MEMO TO: Planning Chairperson Wolter and Planning Commissioners
FROM: Catherine E. Trotter, AICP, Town Planner
DATE: August 22, 2018
SUBJECT: Planner Briefing on EMF11 – Major Subdivision

MATTER BEFORE the Planning Commission
Final Planned Development Plan (Final Plan) and Final Plat – EMF11

The applicant, Rendezvous Colorado, LLC. is requesting Final Plan and Final Plat approval of East Mountain Filing 11 – Planning Area 9E.2.

Map below indicate the general vicinity of Planning Area 9E.2:

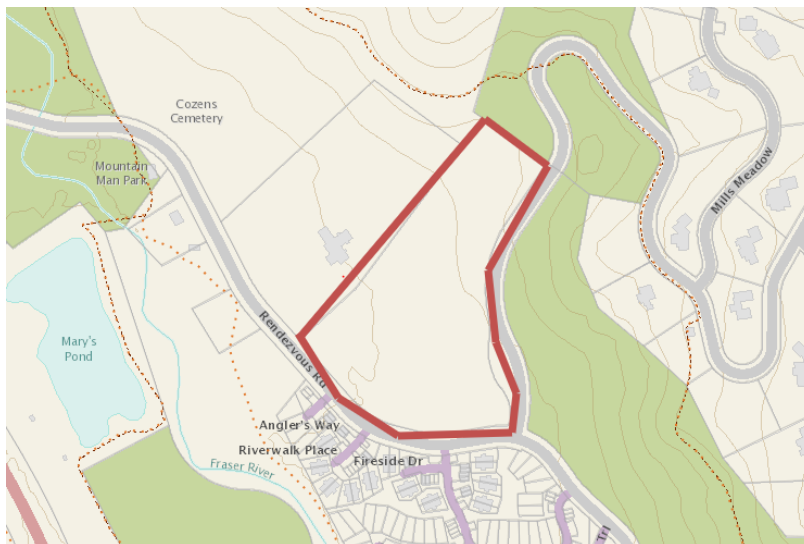
The applicant is proposing 22 single family attached and 11 single family detached homes sites on 6.52 acres. See project narrative. The primary access will be provided via Rendezvous Road and Pioneer Trail. The internal streets shall be private and maintained by the Association.
